DELHI DEVELOPMENT AUTHORITY
(MASTER PLAN SECTION)

NO: F.1(53)/93-MP

Minutes of the meeting of Technical Committee held on 6.10.93 at 4.30 P.M. in the V.C.'s Conference Room of Vikas Sadan, Delhi Development Authority, New Delhi.

Sub:- Alignment plan of Road No.16 along the Eastern side of Jawaharlal Nehru University from Outer Ring Road to Mehrauli-Mahipalpur Road. File No.F.5(3)72-MP. (D-75).
Drawing No. TT-35/PPW/93 (5 parts).

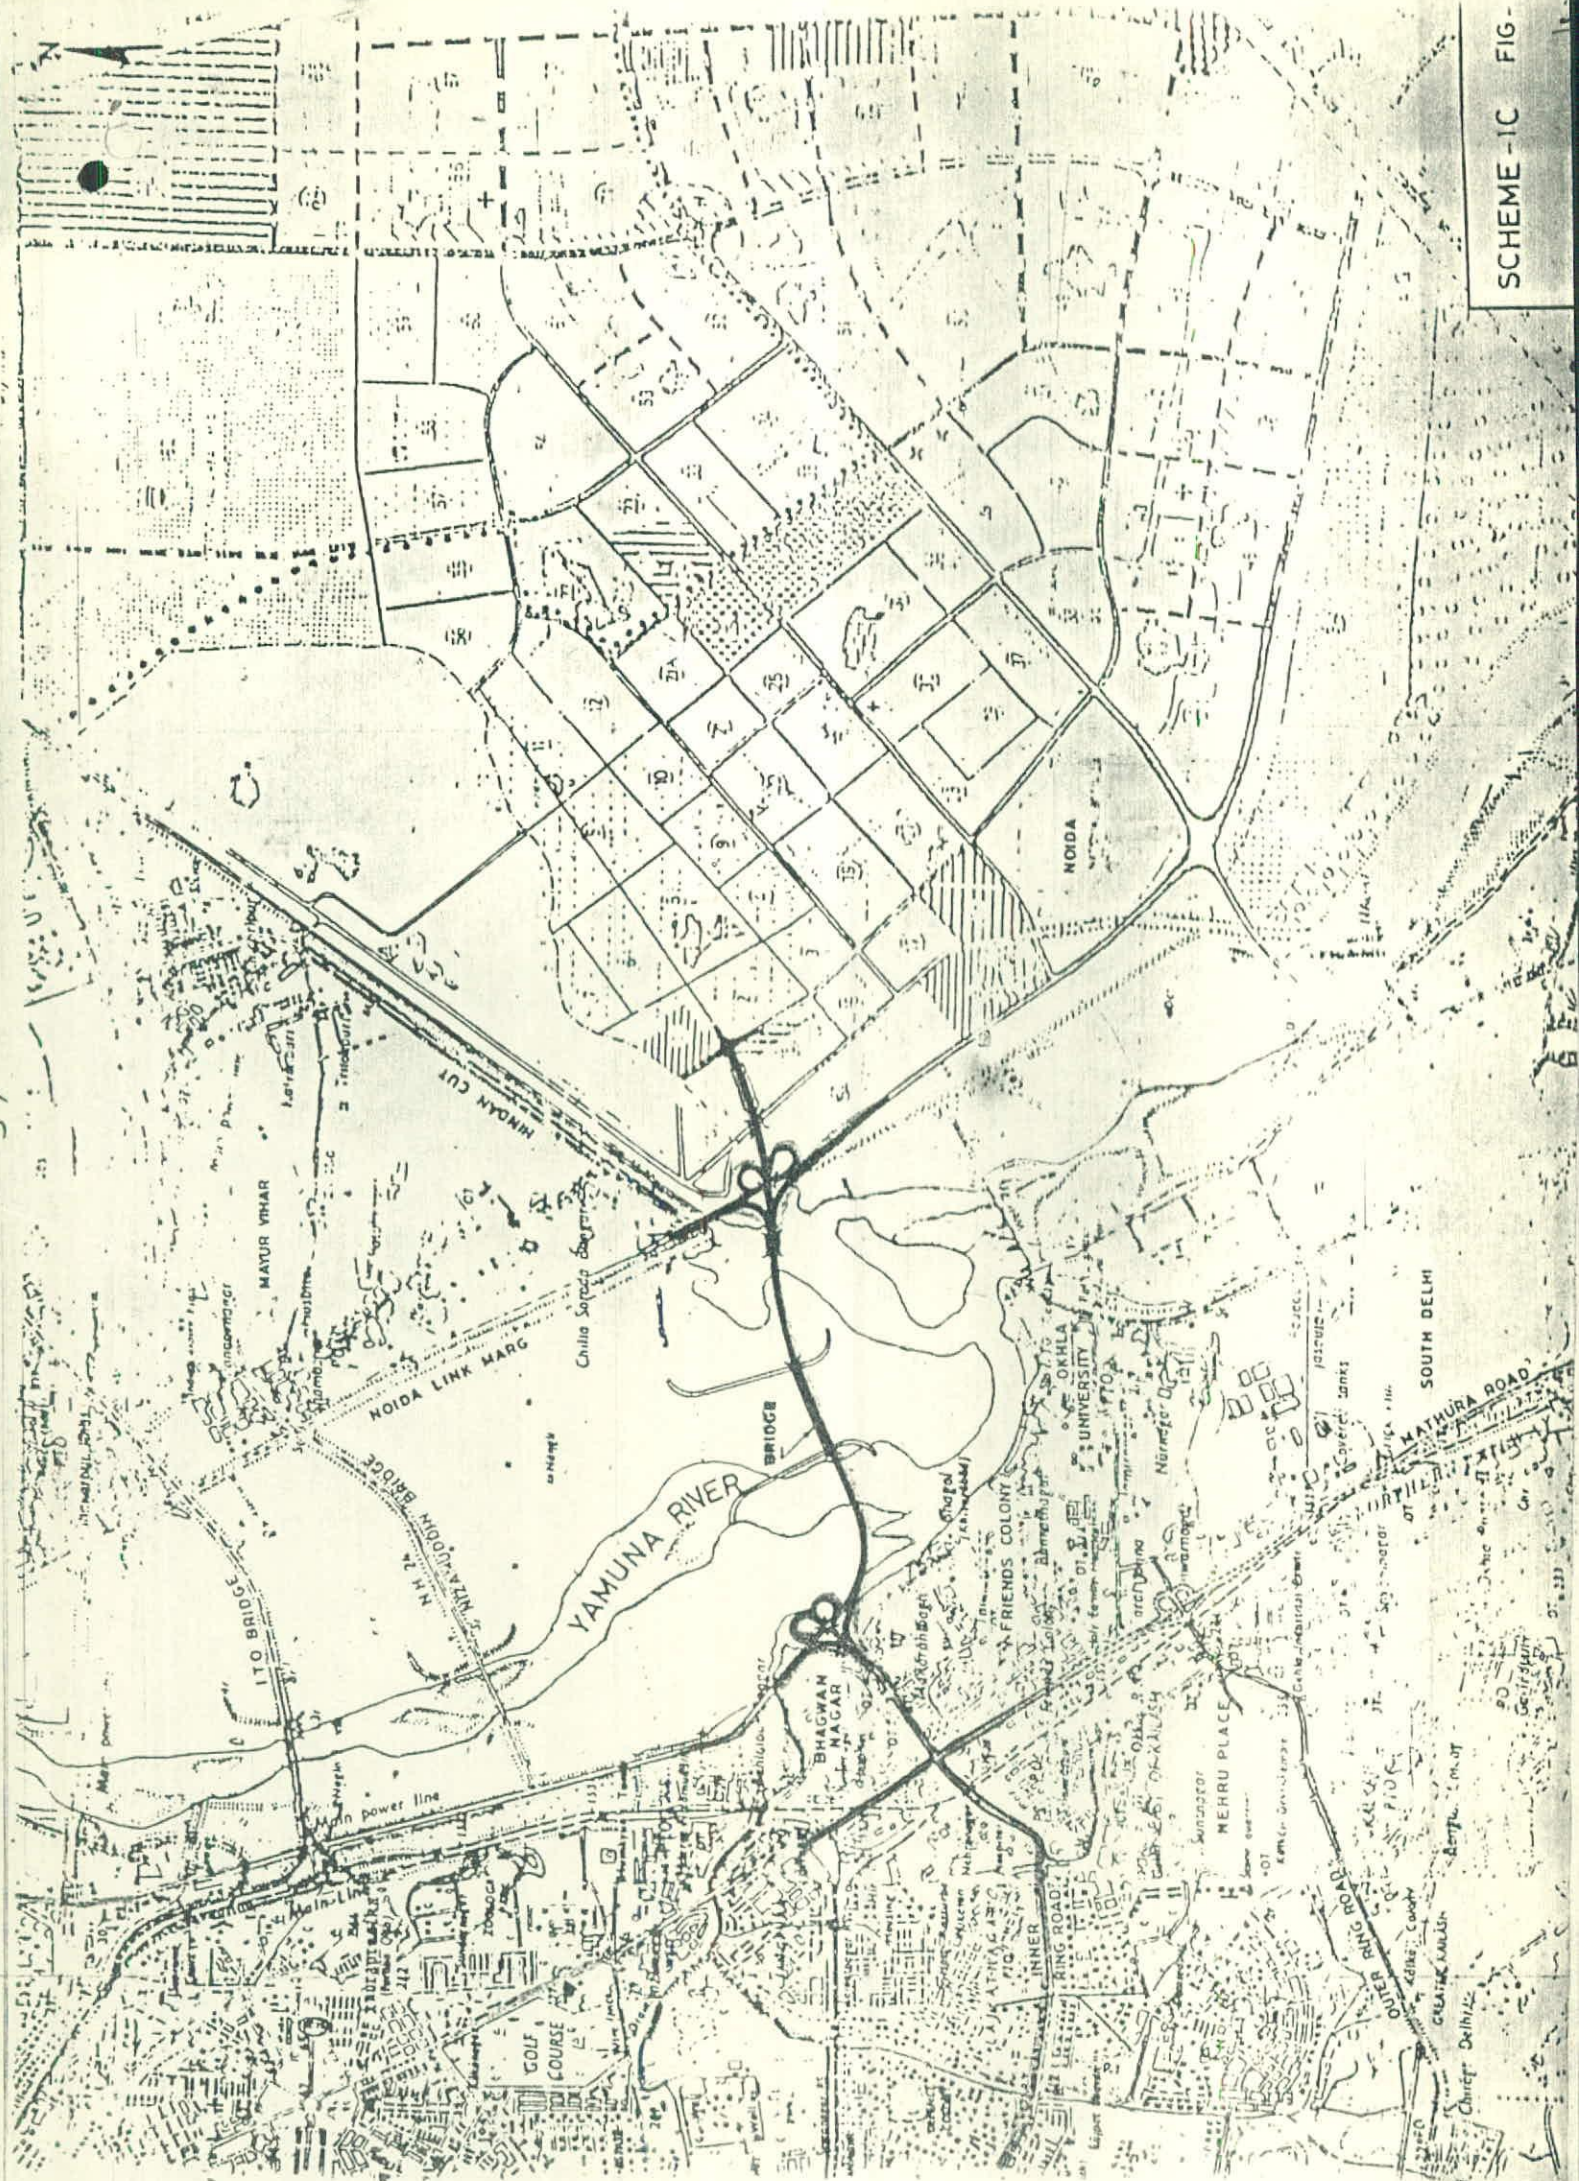
The alignment plan was examined in detail with reference to Technical Committee decision and the point wise observations are as under:

<u>DECISION OF T/C</u>	<u>OBSERVATIONS</u>
1) R/W be kept 45 mts. between institutional area and JNU.	The available r/w in this stretch is 30 mts. The alignment plan has been detailed out by keeping with service road along institutional area, and main carriageway of six lanes with central verge. A service road which is existing in the JNU Campus has been retained. This service road is basically required for providing entry to JNU & other institutional & buildings within JNU Campus. Thus, it is suggested that this road be developed by completing the missing links within JNU Campus by JNU authorities.

3) 45 mts. r/w in the portion where the road is passing through Vasant Kunj Scheme Boundary should be taken equally from the both sides.	To examine this aspect in detail a survey was conducted by DD(S), PPW. It was observed that Vasant Kunj Scheme boundary (Sector-B) has been defined by a barbed wire fence. Some flats are existing very close to the barbed wire. In view of this r/w has been defined by taking the existing barbed wire fencing of Sector-B as one end of R/W and the widening has been proposed towards Kishan Garh village side, the housing layout of Vasant Kunj prepared by HUDA and approved by Screening Committee vide Item No.2 (Residential) on 14.1.98 also envisaged the widening towards Kishan Garh Village.

The right of way of this road be kept as 45 mts. except for that portion of the road which passes along the Master Plan recreational area and falling between the institutional area developed by the DDA and the Vasant Kunj Scheme where the right of way could be developed as 30 mts. without providing for a service road. Further, the institutional plots allotted within the JNU Complex.

Technical Committee desired that the detailed alignment plan be prepared accordingly and put up to the Tech. Committee".

LOCATION PLAN

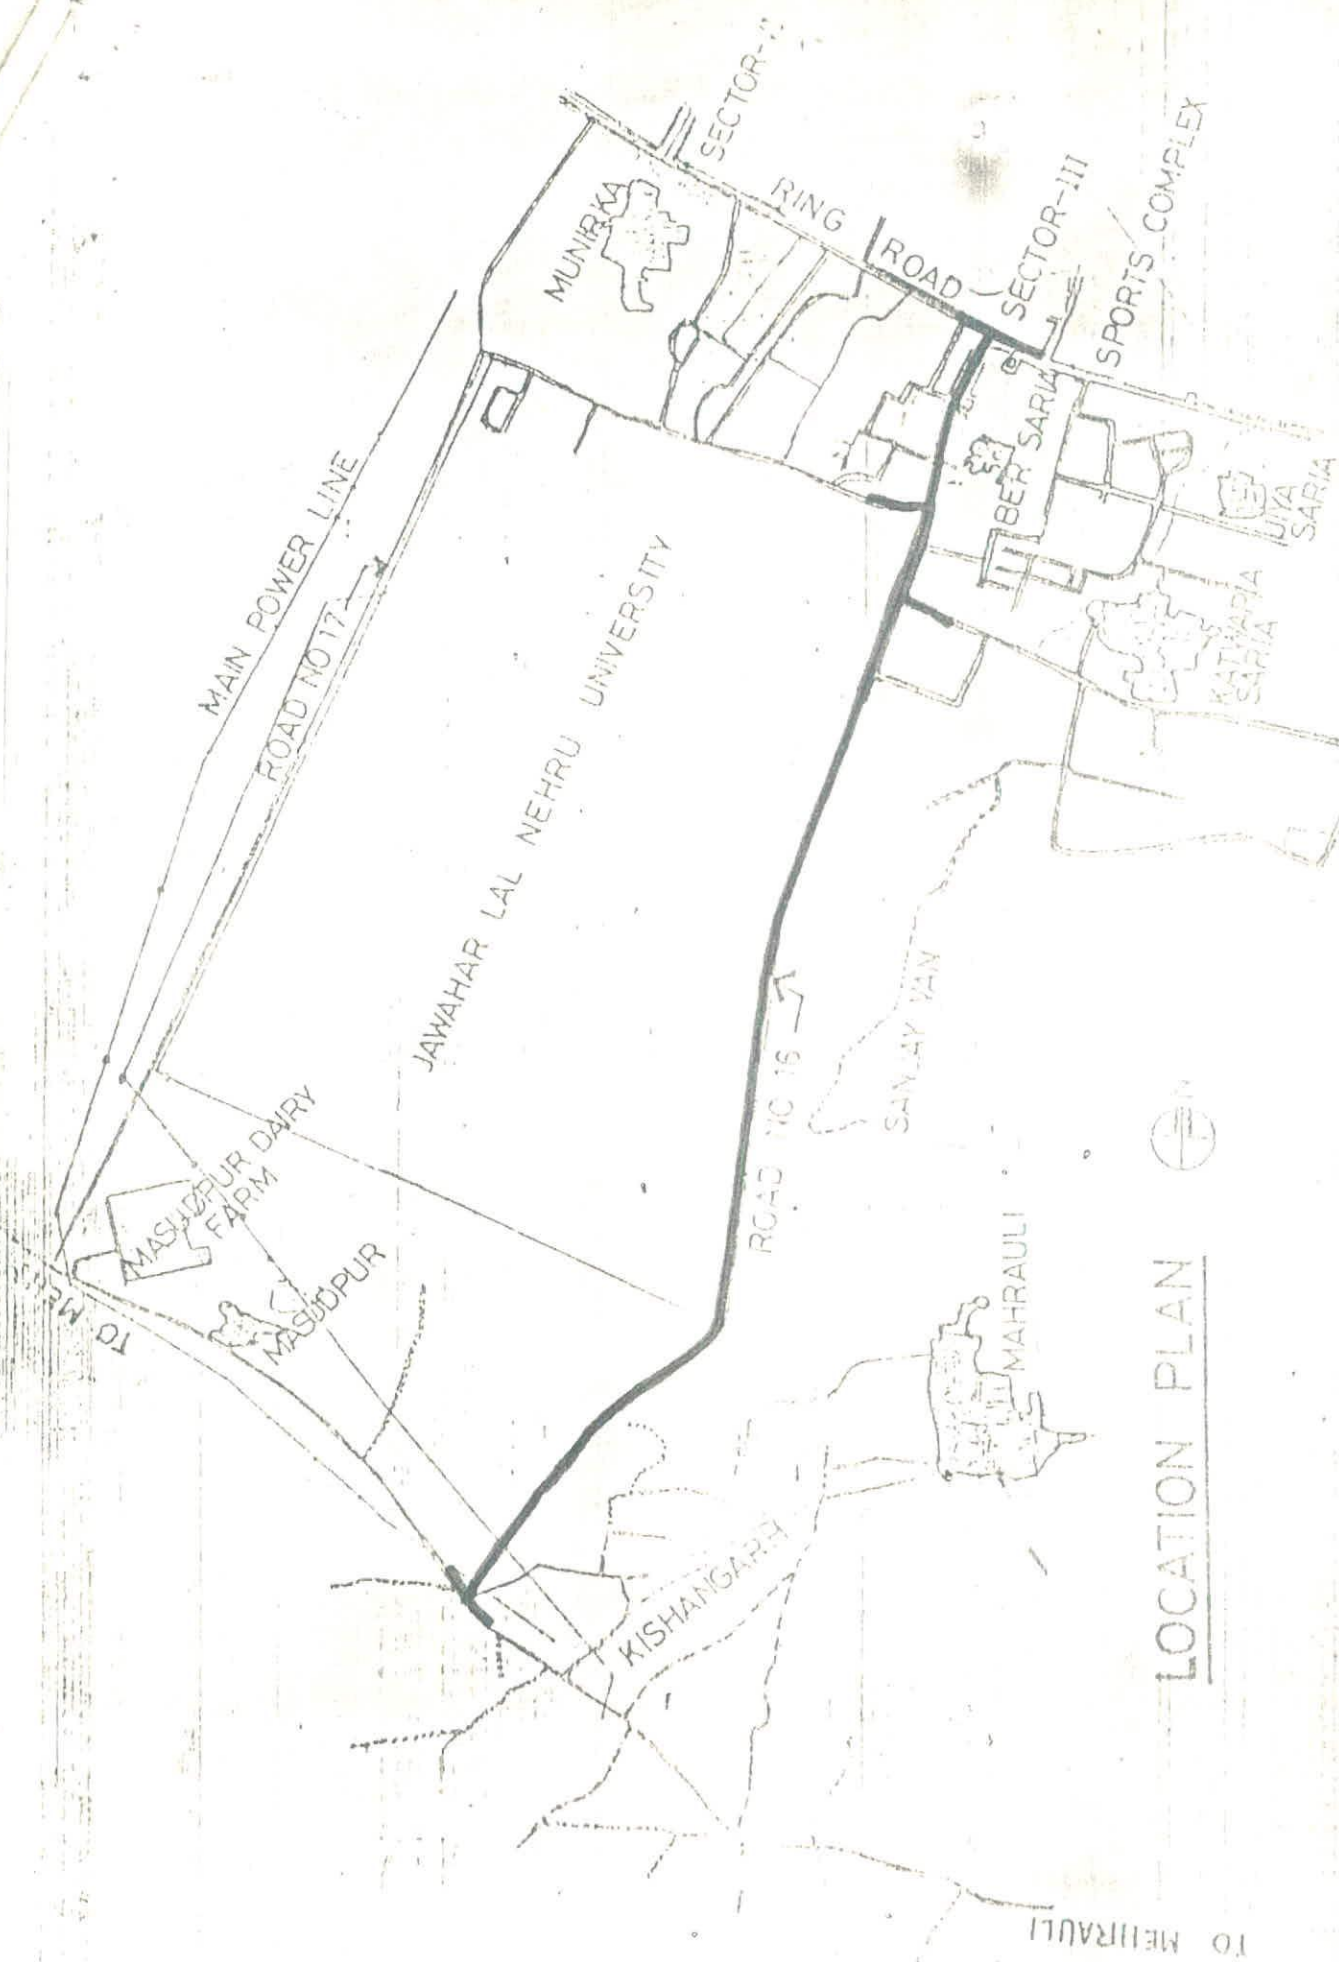
On the basis of above observations a revised alignment plan was prepared and sent to PWD for feasibility. It was observed from the revised feasibility report received from Ex.En., PWD, Division-VII, NCTD on 16.4.93 that a large number of trees and number of unauthorised structures were affected in the proposed r/w.

To minimise the cutting of trees etc. a joint site inspection was conducted by J.D.(T), & Land Scape Architect, DDA Ex.En., Division-VII, PWD, NCTD and D.D.(T)II, DDA. At site Ex.En.(PWD), NCTD was also requested to incorporate the existing boundary walls of JNU, Sanjay Van and Vasant Kunj Scheme. Based on the location of trees as supplied by J.E., PWD the alignment was again revised. The details of the revised alignment are as under:

The available R/W in this stretch is 30 mts. The alignment plan has been detailed out by providing a service road of 5.5 mts. width along the institutional area developed by DDA and 6 lane divided main carriageway of 20 mts. width with 0.5 mts. central verge. The service road existing within JNU Complex has been retained. This service road is proposed to be maintained and developed by completing the missing links upto Road No.12 by JNU Authorities, since this will provide mainly access to JNU Complex only.
